**DEPARTMENT OF TRANSPORTATION**

Contract #: 04-0120F4Cty: SF/ALA Rte: 80 PM: 13.2/13.9File #: 69.28**WELDING INSPECTION REPORT****Resident Engineer:** Pursell, Gary**Address:** 333 Burma Road**City:** Oakland, CA 94607**Report No:** WIR-013140**Date Inspected:** 22-Mar-2010**Project Name:** SAS Superstructure**OSM Arrival Time:** 700**Prime Contractor:** American Bridge/Fluor Enterprises, a JV**OSM Departure Time:** 1900**Contractor:** Zhenhua Port Machinery Company, Ltd (ZPMC), Changxing Island **Location:** Shanghai, China**CWI Name:****CWI Present:**

**Bridge No:** 34-0006**Component:** OBG Trial Assembly**Summary of Items Observed:**

Orthotropic Box Girder (OBG) Trial Assembly Areas

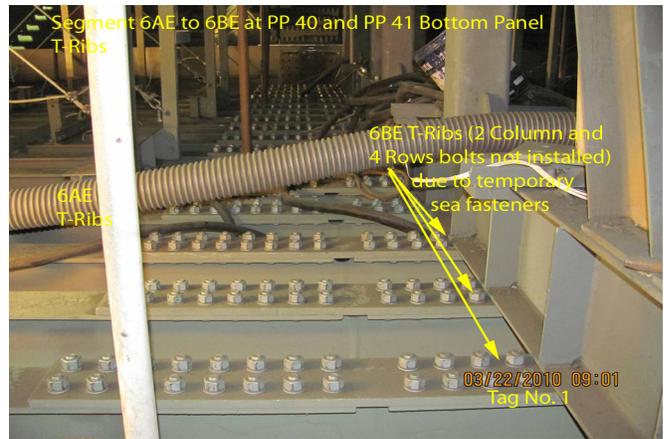
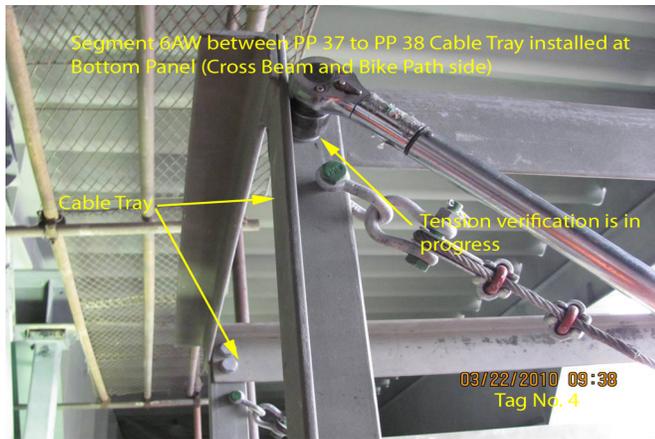
and not offered for tension verification due the temporary sea fasteners interfering at that location. At Segment 6AE Side Panel Cross Beam side 13th T-Rib from E4 location 2 Column and 8 Rows bolts stick out was not flush thus asked ZPMC QC to replace M22x65 with M22x70 as per the adjacent T-Ribs bolts to meet the requirement ZPMC thus the tension verification at that location not performed. Please refer the pictures attached with Tag No. 1 and 2 below for more comprehensive detail.

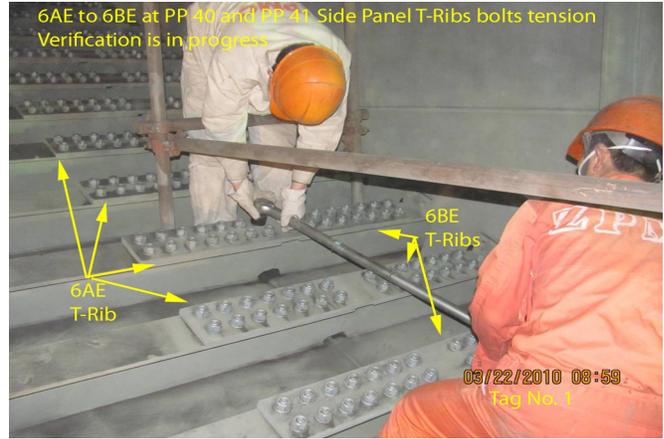
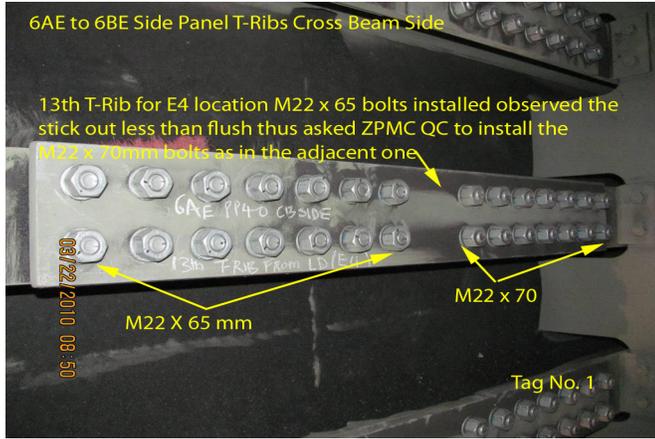
Please refer the pictures with Tag no. 4 for more comprehensive details.

Note: for Segment 6AW between PP 38 and PP 39 Cable Tray bolts not installed due to interference with Temporary Sea Fasteners.

Please refer the pictures attached with Tag No. 4 below for more comprehensive detail.
